Staff Report: Limited Site Plan Amendment 82004015F, Park Potomac

MCPB HEARING October 8, 2009

DESCRIPTION: Add a road connection between Park Potomac Avenue and the adjacent

Overall Site Plan, with proposed road connection

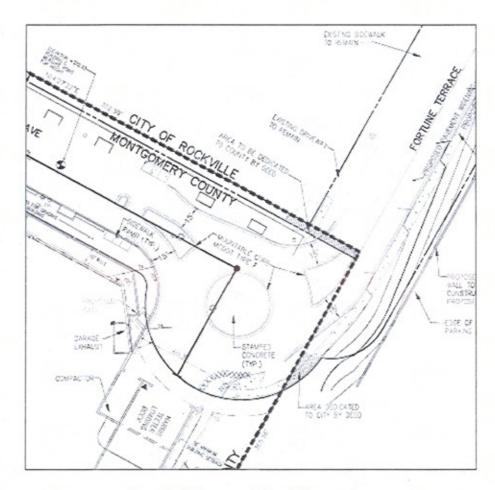
- · Add a roadway connection from Park Potomac Avenue to Fortune Terrace;
- Move the bike racks from the front of Condo Building #1 to inside the garage of Condo Buildings #1 and #2;
- Adjust brick paver lead walks of Condo #1 to match as-built conditions;
- Add wrought-iron fence around the pool and the pool pump room;
- Add structure for the pool pump room;
- · Adjust landscaping at Condo #1.

The road connection between Park Potomac Avenue and Fortune Terrace is a natural extension of this development and was supported by staff at the time of the 82004015B Site Plan Amendment. At that time, however, the Applicant was unable to secure the necessary approvals from the City of Rockville. The Applicant has now obtained the necessary approvals.

Staff does not recommend removal of the bike racks from in front of Condo Building #1 to inside the garage for Condo Buildings #1 and #2. This is inconsistent with the promotion of bicycle transit through the convenient, accessible, and visible placement of bike racks at building entrances, and is presently not in compliance with the approved Planning Board conditions.

- a. The Applicant must locate the inverted-U racks in front of the main entrances to the apartment and commercial buildings for visitor's short-term bicycle parking. Final location will be determined at Certified Site Plan.
- b. The Applicant's plan for the proposed traffic circle at Park Potomac Avenue and Fortune Terrace must include adequate handicapped ramps to be ADA accessible from all directions.
